**ADDENDUM NO. 1**

**CID 01-STILLHOUSE BRANCH WASTEWATER TREATMENT FACILITY  
IMPROVEMENTS**

**PROJECT NO.: 2-01590 | TWDB CWSRF NO. 73776**

**DATE OF ADDENDUM: MAY 24, 2023**

G:\PROJECTS\2-01590\2 DESIGN\2.0 CAD\WWTP\C-PIPING.DWG, C-13, 5/23/2023 5:05:33 PM, paidderson

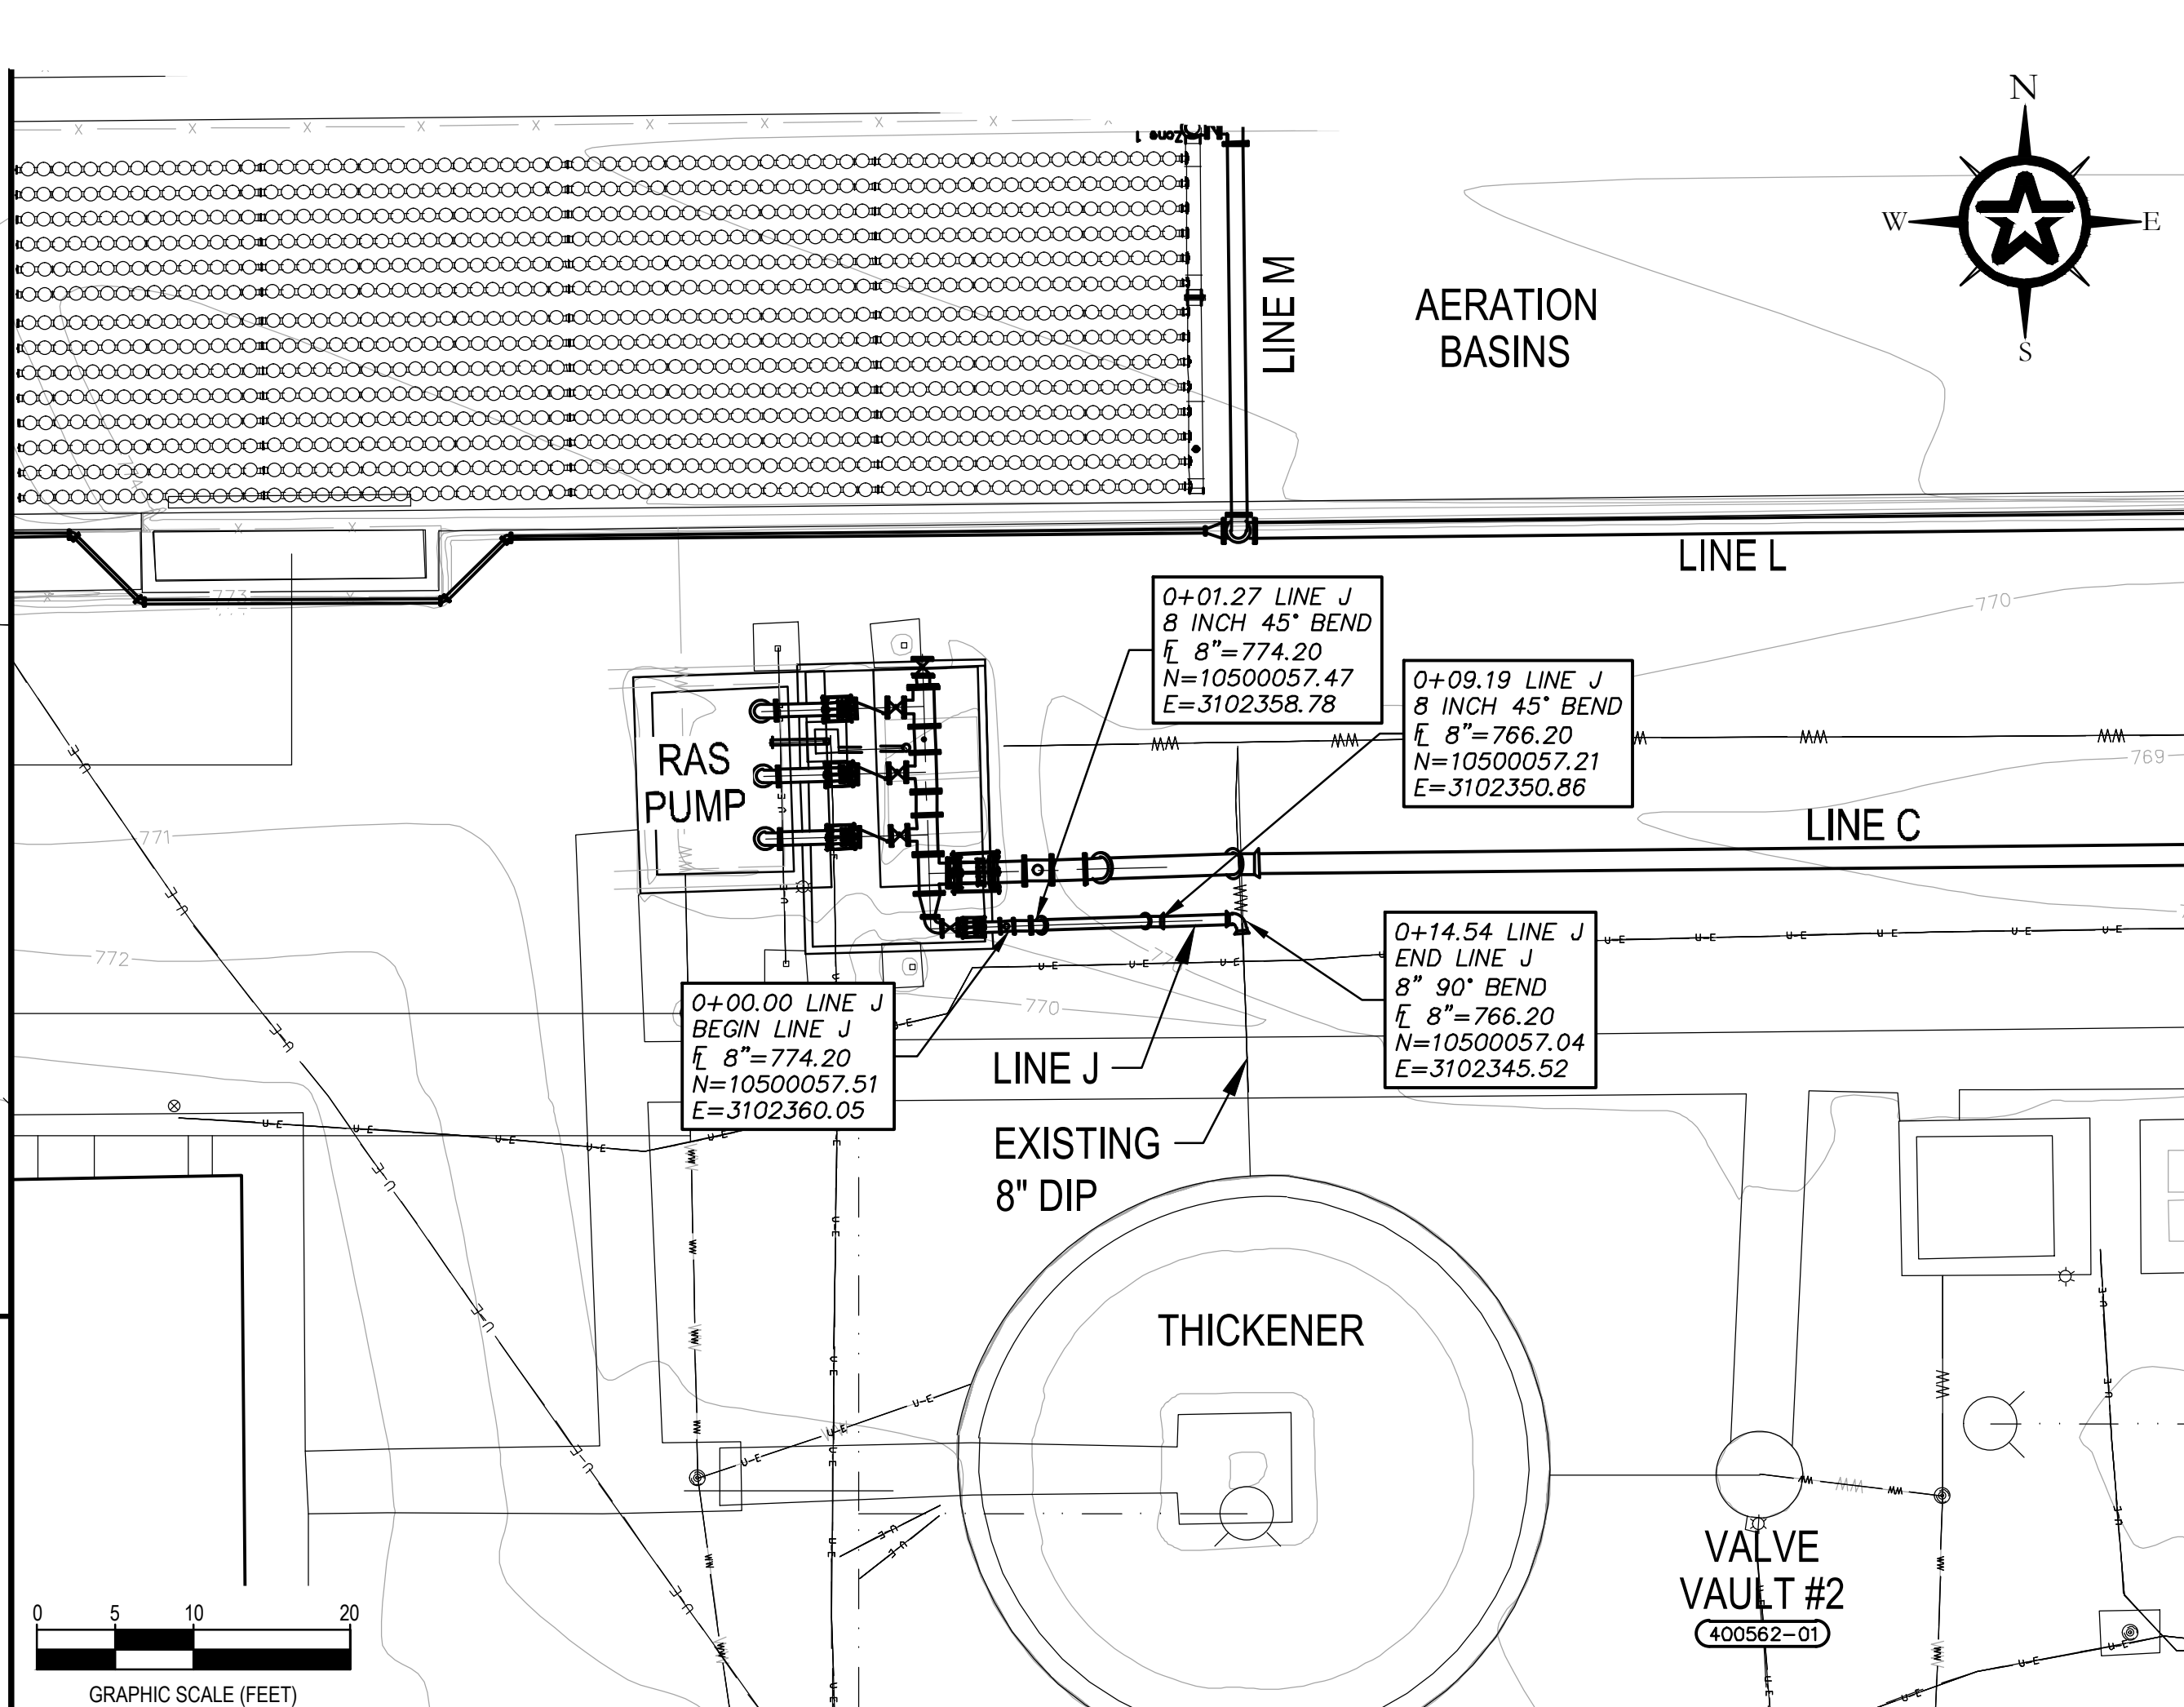
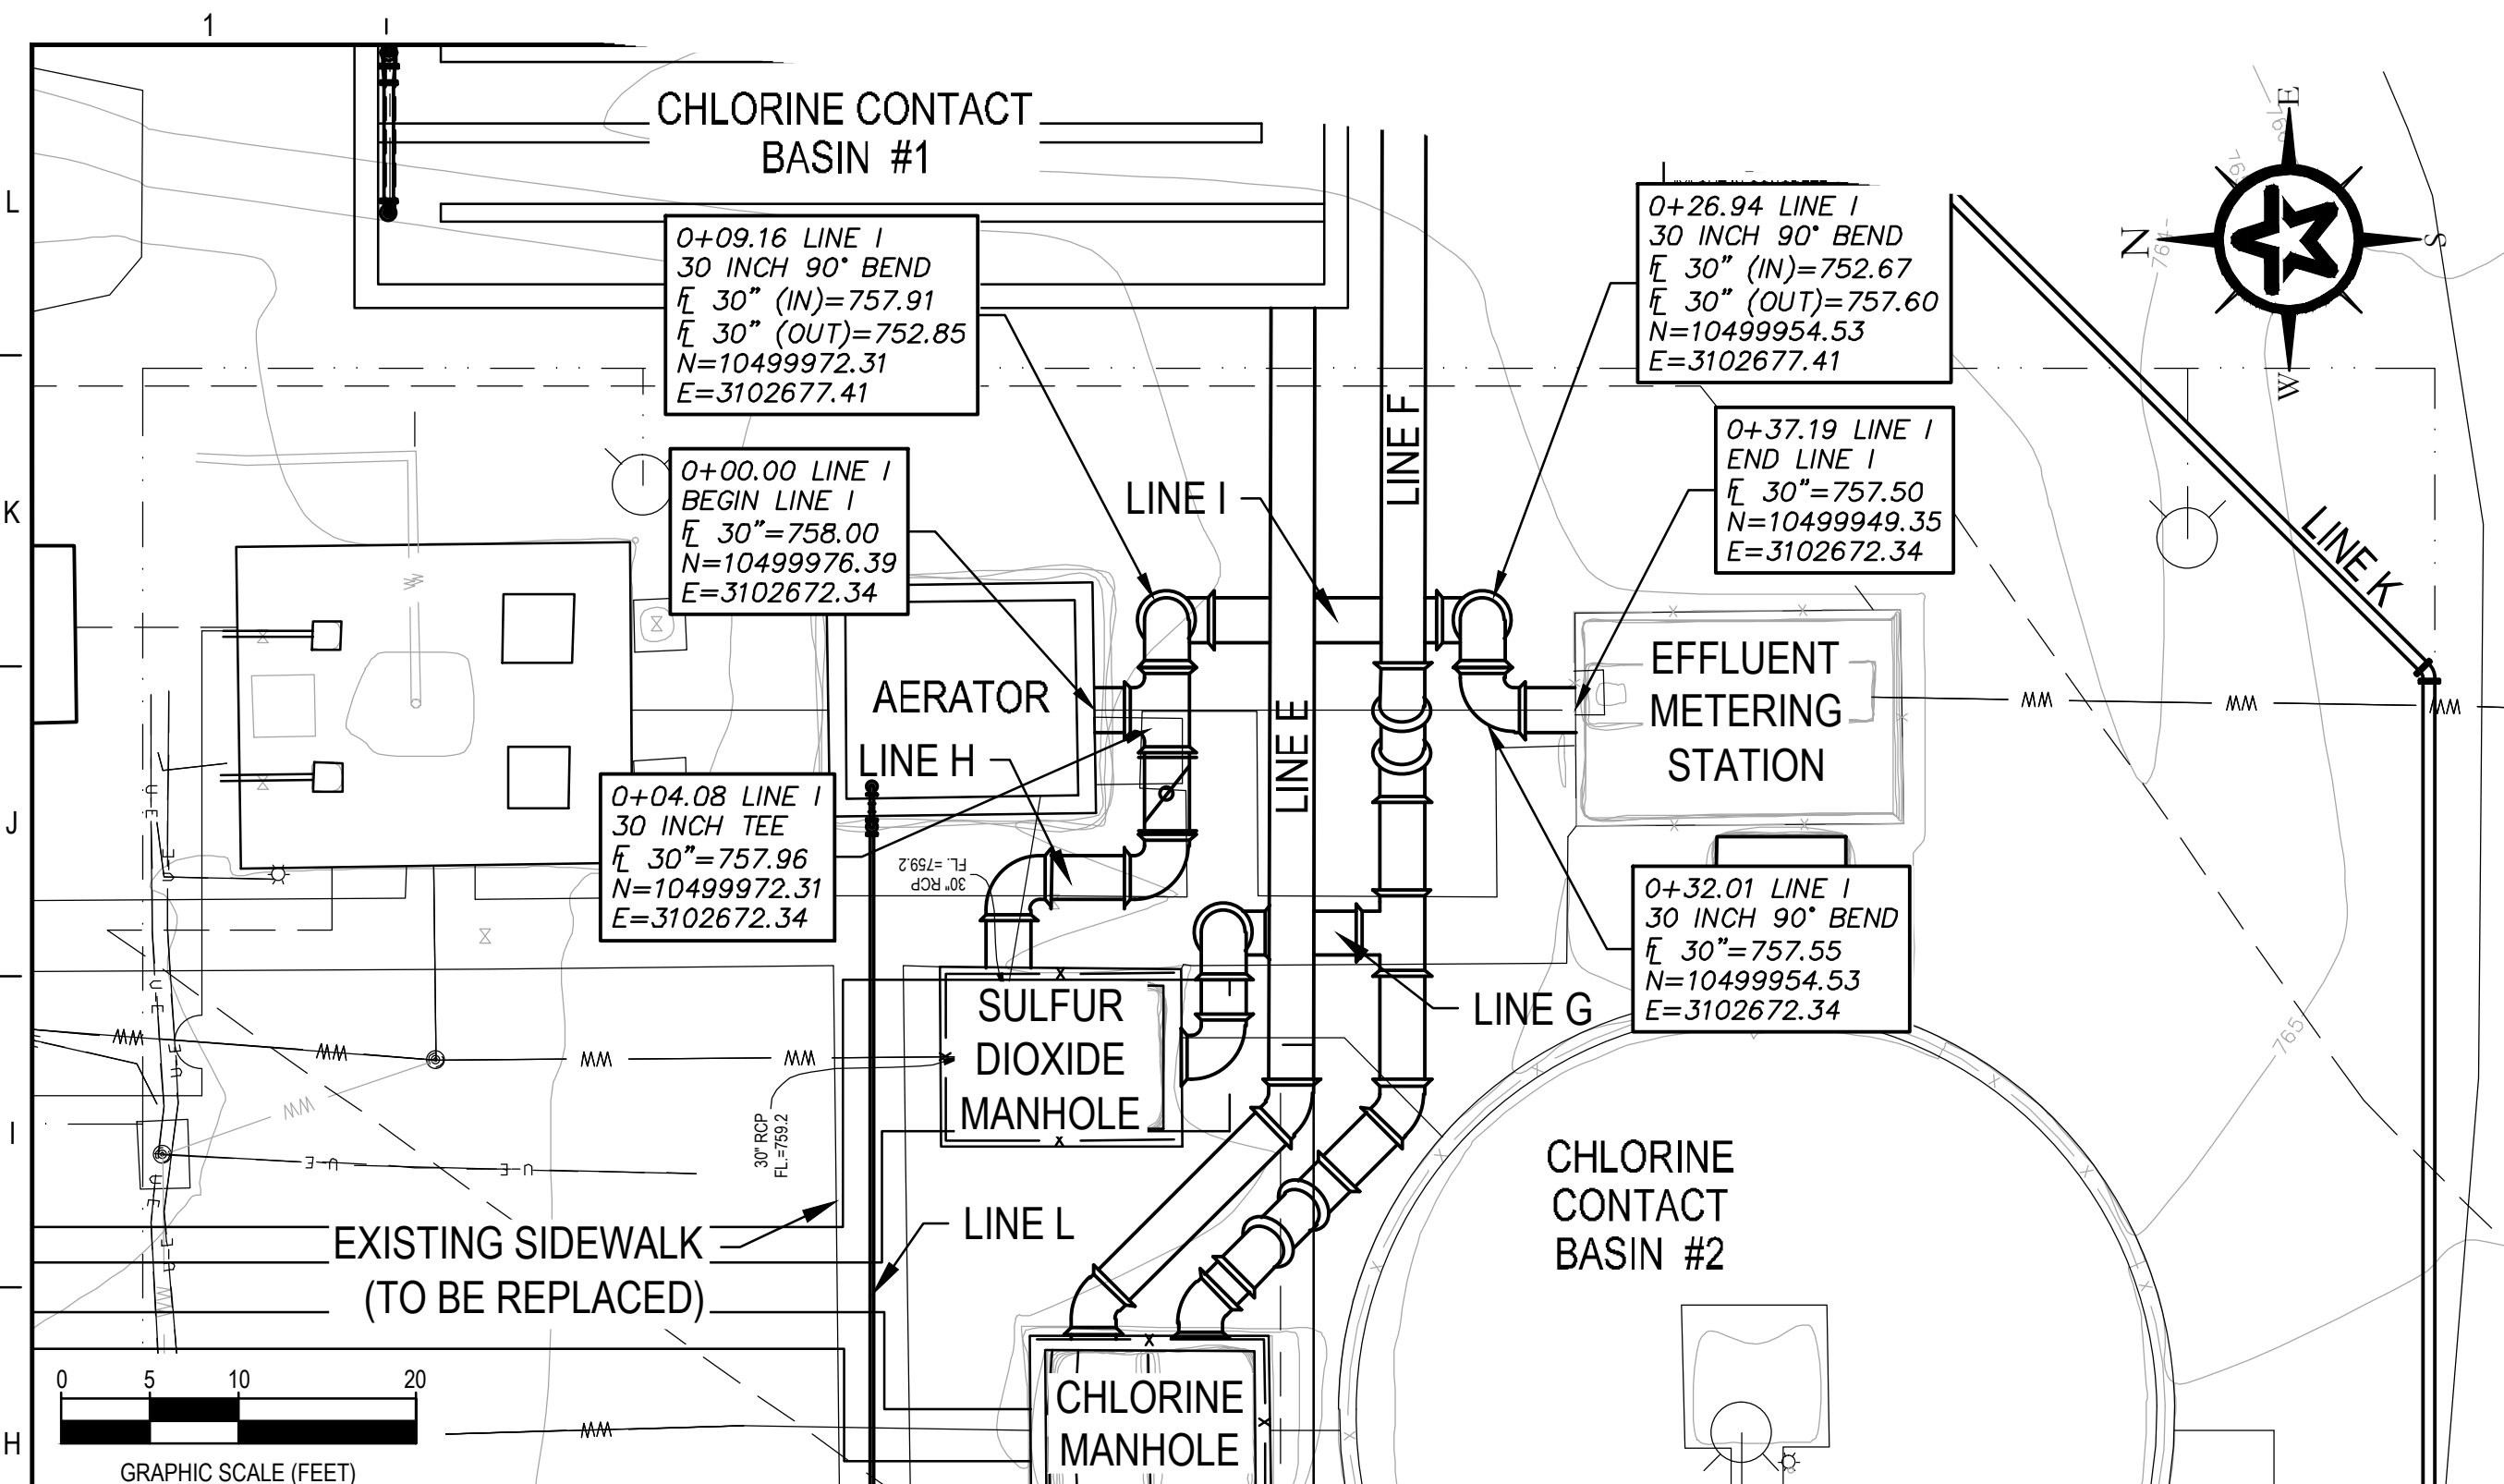
a. Sheets C-08 through C-17

REVISE yard piping to reflect the pipe labels on Sheet M-01 and Sheet M-02.
